**RE: San Roque / La Serena
441 & 457 Coors Blvd NW
Grading & Drainage Plan and Drainage Report
Engineer's Stamp Date: 11/10/21
Hydrology File: J10D049**

**RE: RESPONSE TO HYDROLOGY COMMENTS
SAN ROQUE / LA SERENA
441 & 457 COORS BLVD NW
GRADING & DRAINAGE PLAN AND DRAINAGE REPORT
HYDROLOGY FILE: J10D049**

**San Roque & La Serena Developments
Albuquerque, NM**

Storm Drain
Plan

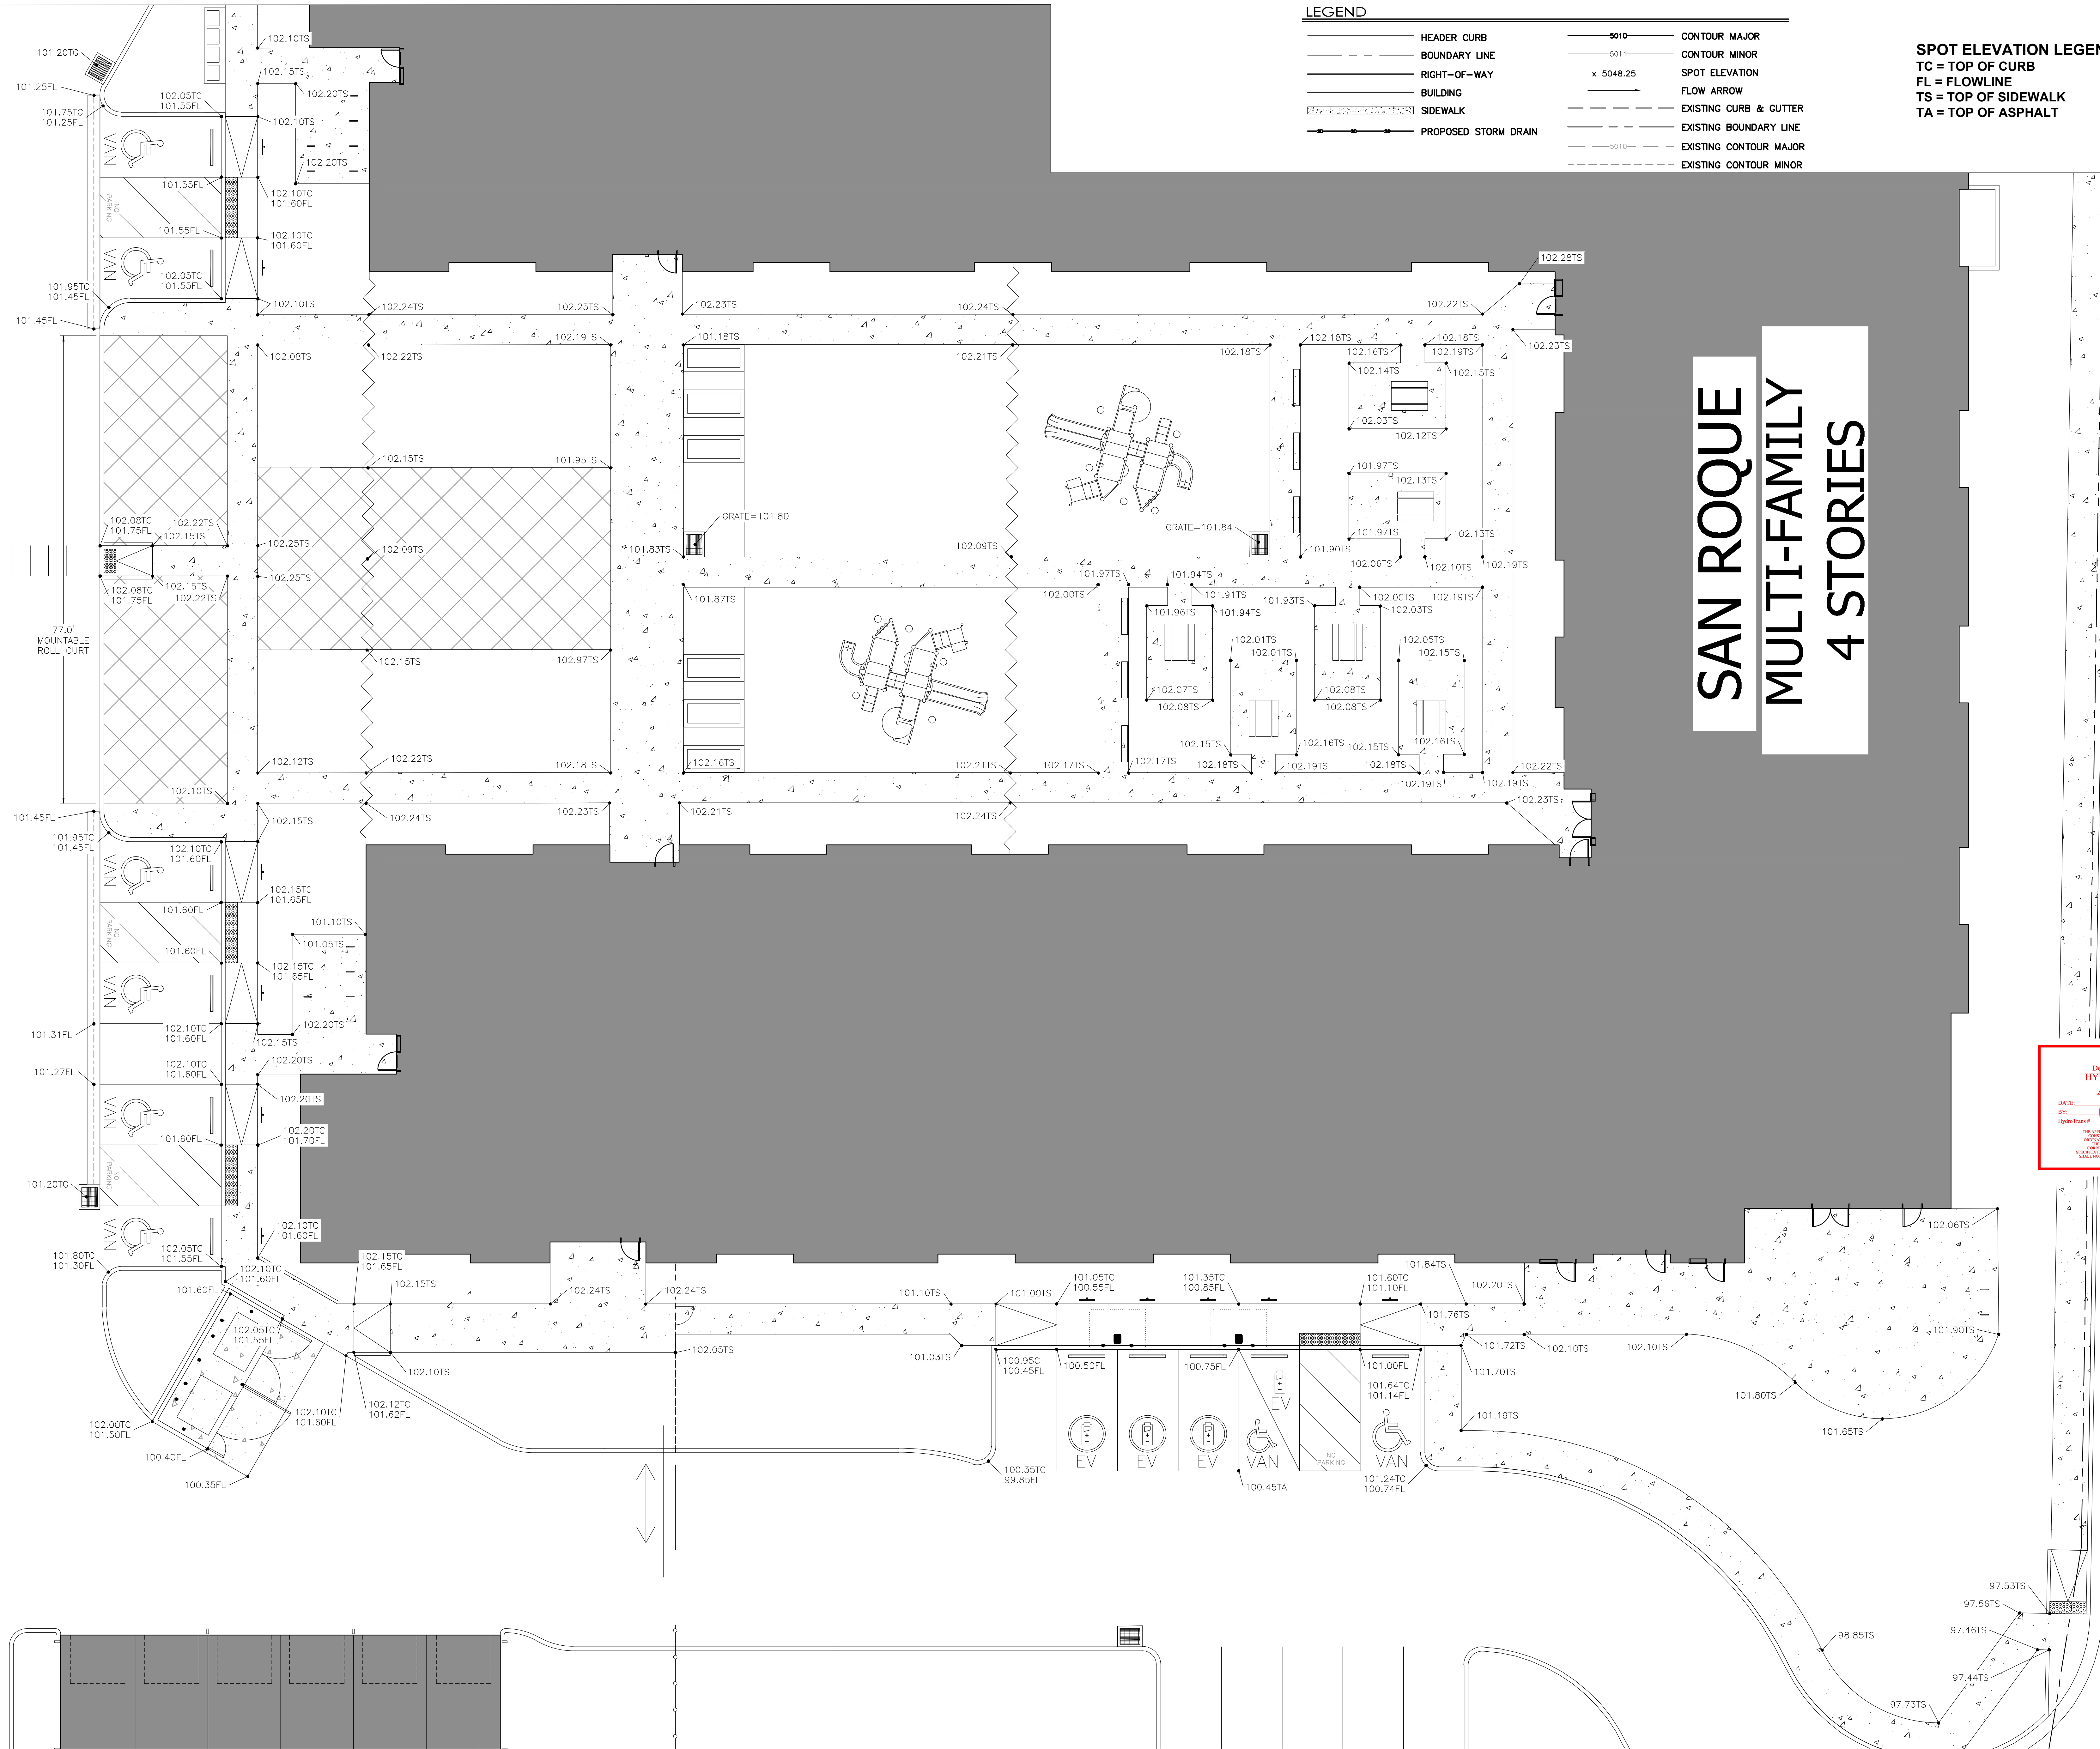
8. Sheet 2.3. Depending on the new design, this storm pipe layout may change.
Response: Although the drainage ponds along the west side have been reduced to only retain the stormwater quality volume, the storm pipe layout remains similar just due to the existing and proposed grading, with the outfall being in the NW corner and the low point of the property being at the SE corner. The storm pipe layout has been updated and sheet 2.3 shows revised grate and invert elevations.

Grading
Enlarged
Area 1
c2.4

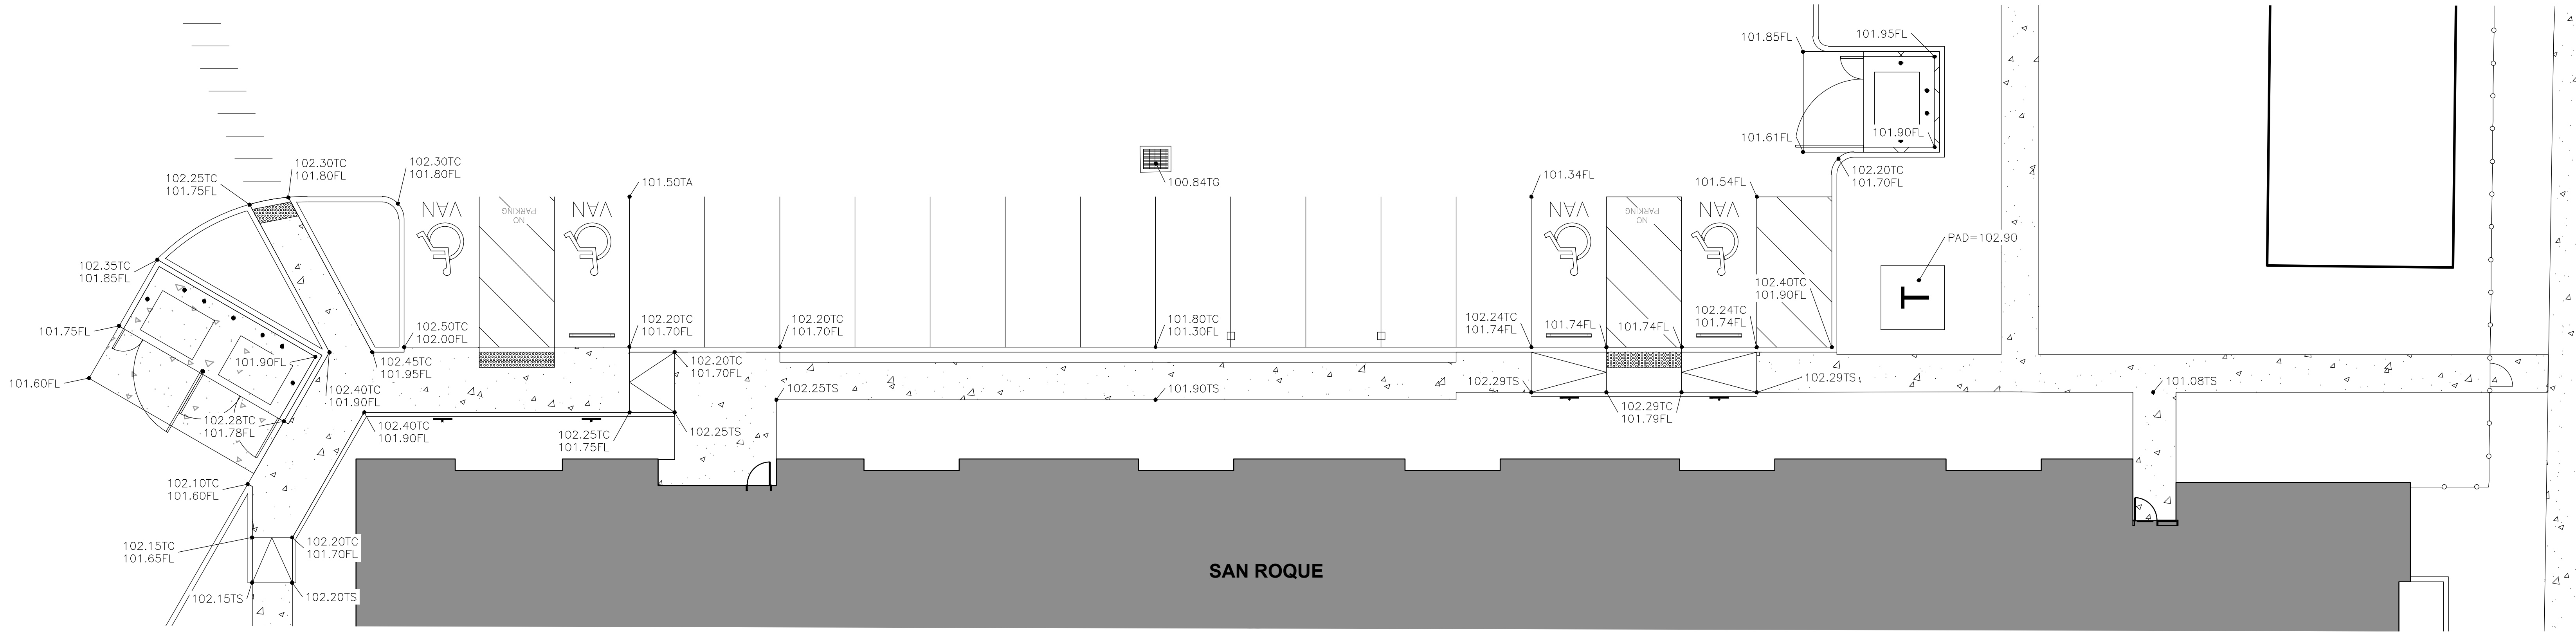
9. Sheet 2.4, 2.5, & 2.6. Please change the title from "Grading Details" to "Grading Enlarged Area". Also on sheet 2.0, please show these areas and label them to go to the correct sheet.

Response: The titles of sheets 2.4, 2.5, and 2.6 now read "Grading Enlarged Area..." with the viewport windows and sheet number references called out on the Overall Grading Plan sheet 2.0.
